**RE: 1001 Adobe Rd. NW
Grading and Drainage Plan
Engineer's Stamp Date: 10/07/22
Hydrology File: F14D081**

Based upon the information provided in your submittal received 10/12/2022, the Grading & Drainage Plan is approved for Grading Permit (earthwork can get started for the earth pad on the house).

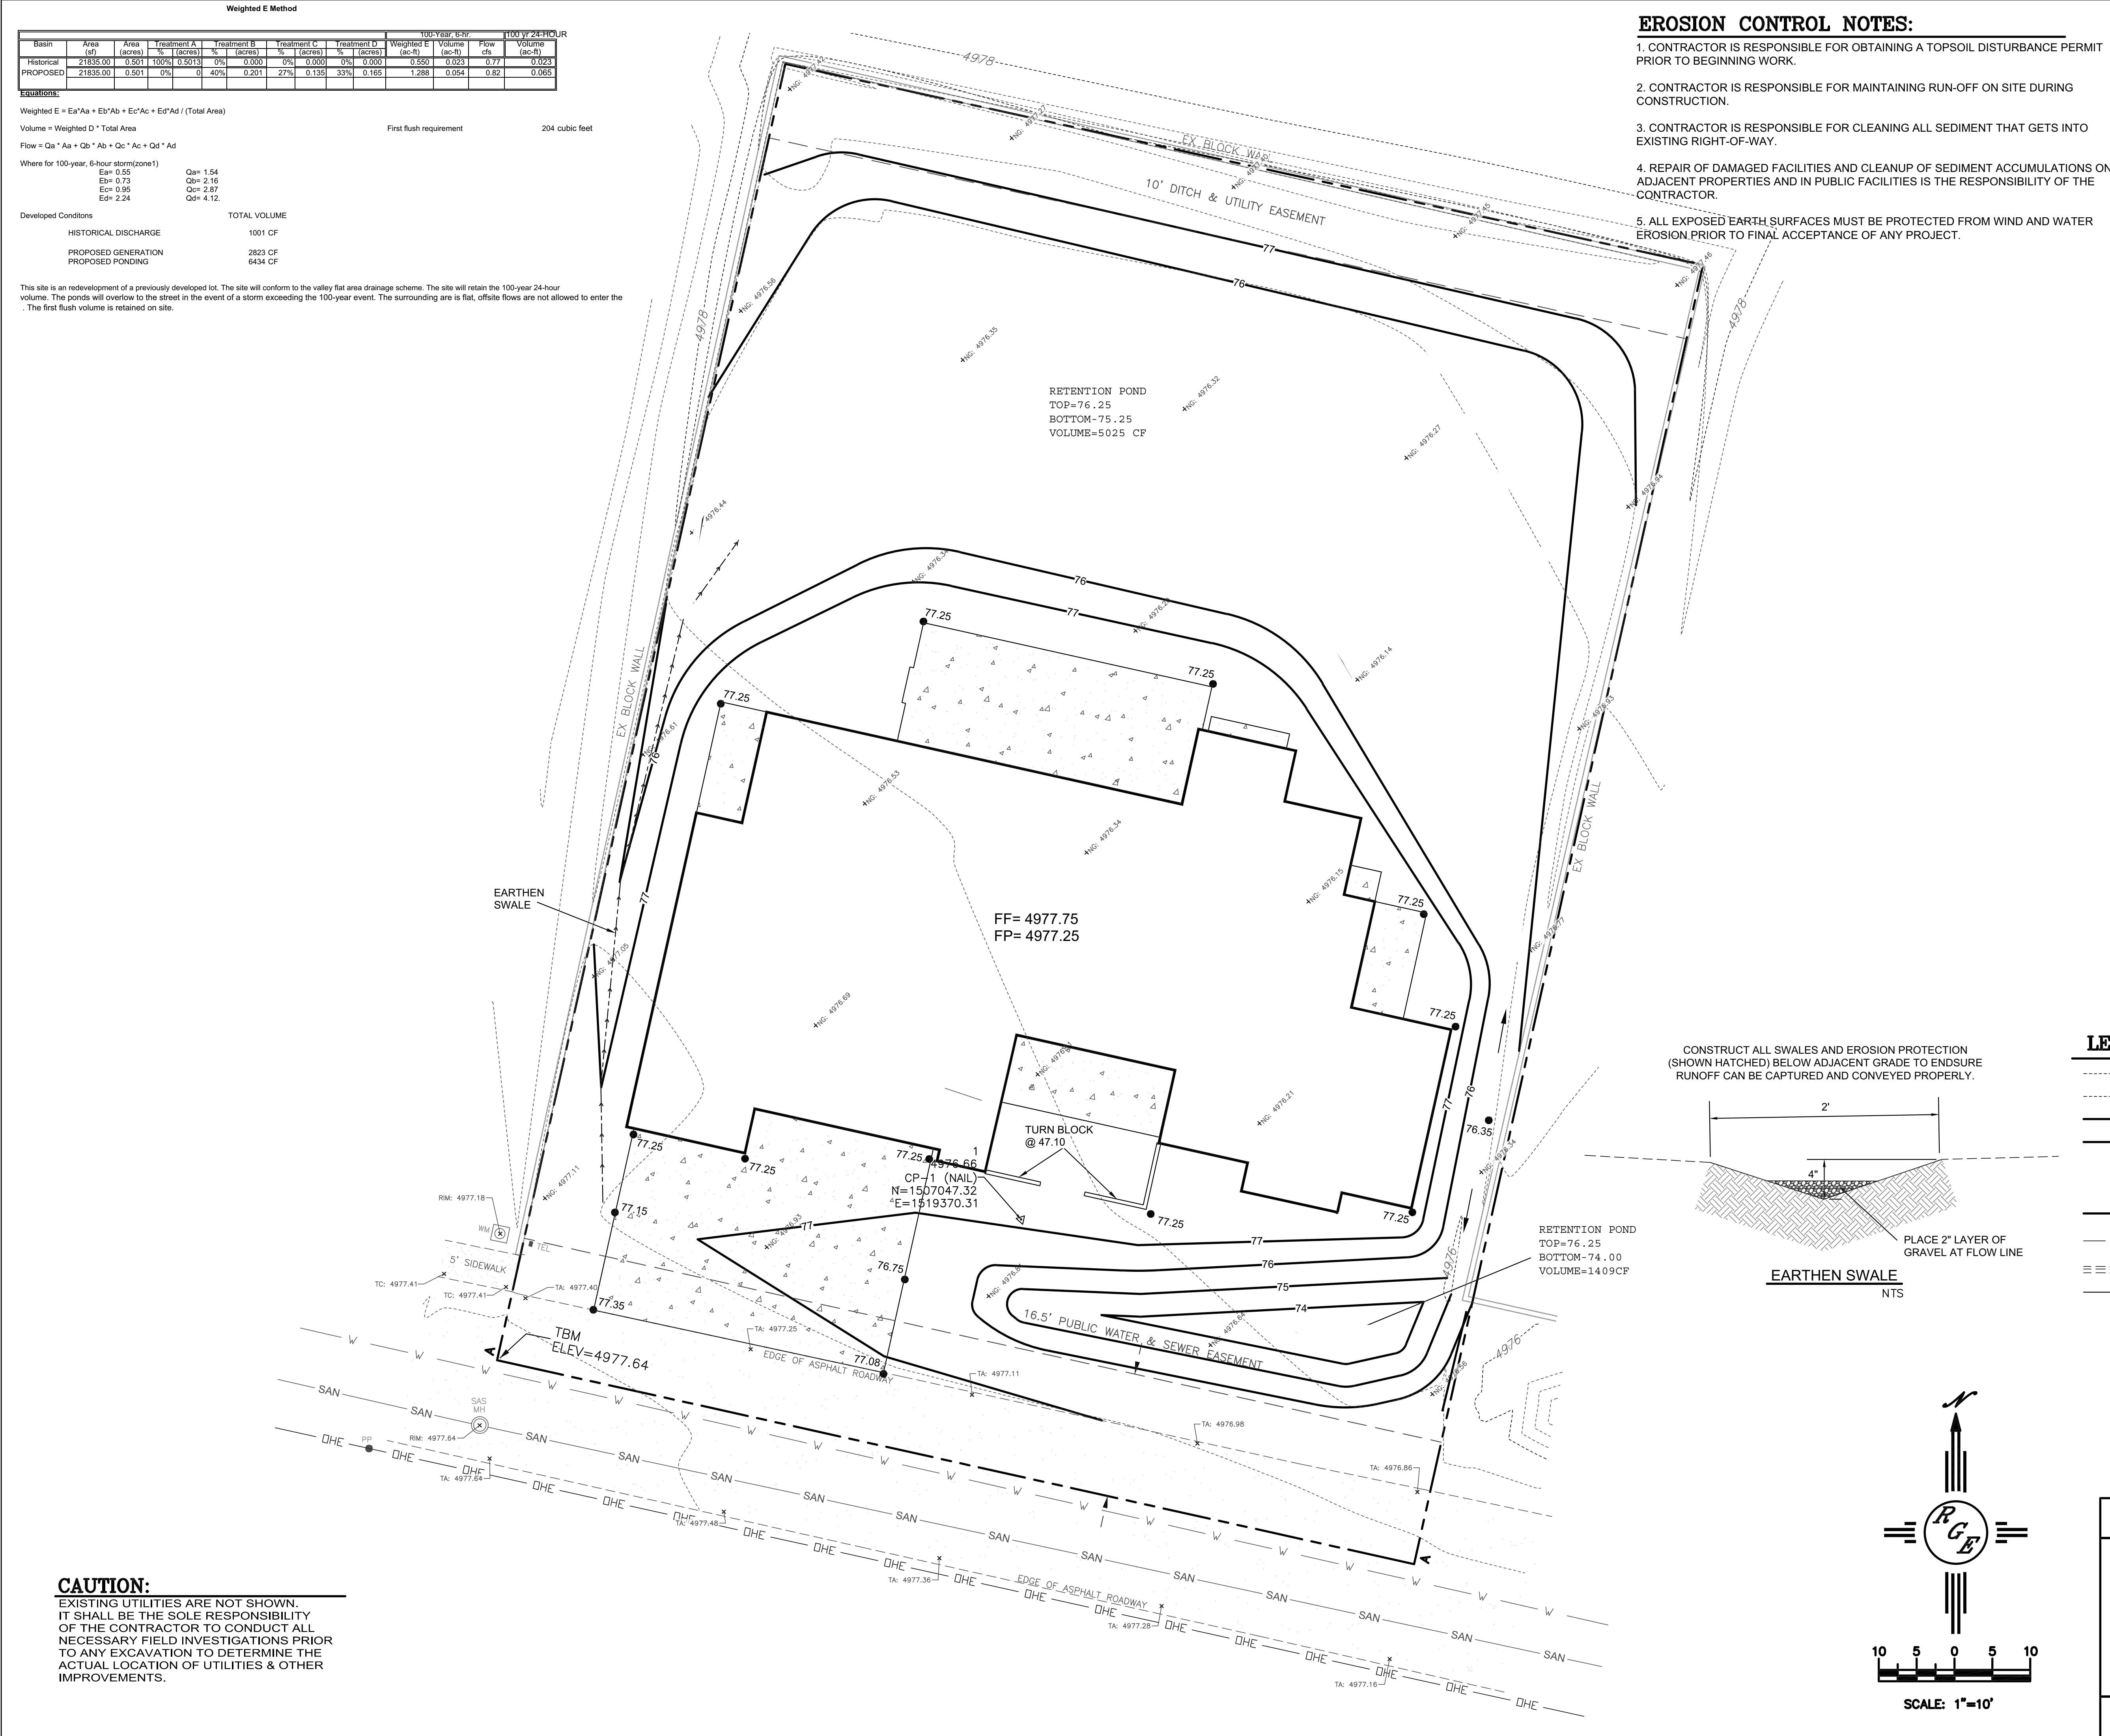
1. Once the grading is complete, a pad certification (meaning that the earthwork is complete) will be required. Please include a site photo with the submittal. Also, at the time of pad certification approval, Hydrology will concurrently approve the Grading & Drainage Plan for Building Permit.
